MS-17-00390: A Minor Subdivision/Replat of Blocks 11 & 12 Sunset Hill Estate Subdivision located at 2515 W 6th Street. Submitted by Paul Werner Architects for D & D Properties of Lawrence, Inc., property owner of record.

ADMINISTRATIVE DETERMINATION: The Planning Director approves the above-described Minor Subdivision, subject to the following conditions:

Figure 1b. Proposed replat.

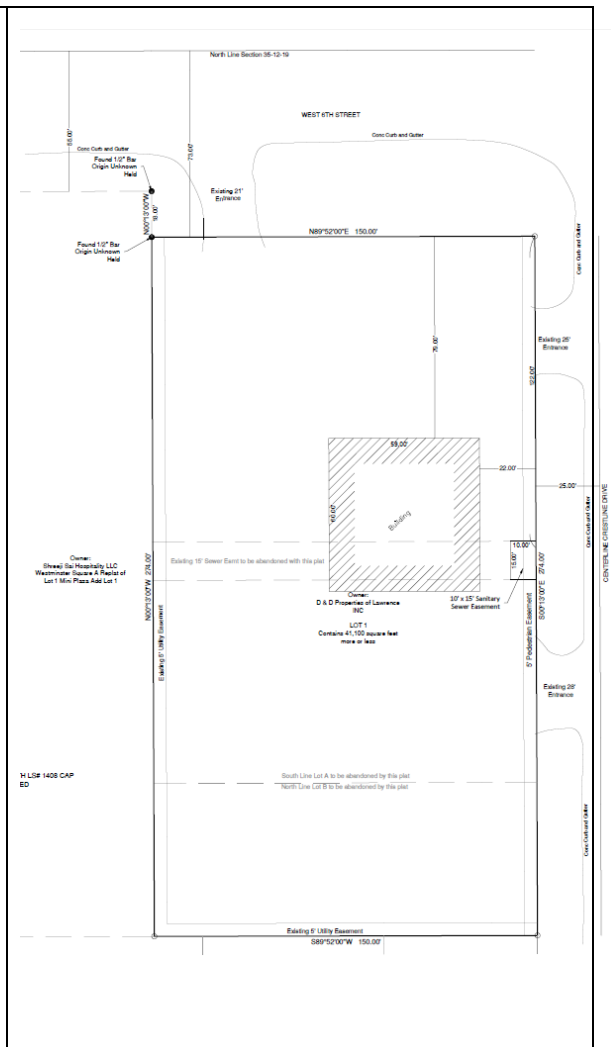
1. Add a note confirming the variance by the Planning Commission for a reduction in right-of-way for W 6th Street and Crestline Drive.
2. The County Surveyor is now Kevin Sontag. Please revise the plat with the new County Surveyor name.
3. Per Resolution No. 17-31, the minimum cap height for the text (letters and numbers) shall be 1/10th of an inch. Please revise with text size to meet that requirement.
4. Submission of mylar with signatures and recording fees for this Minor Subdivision
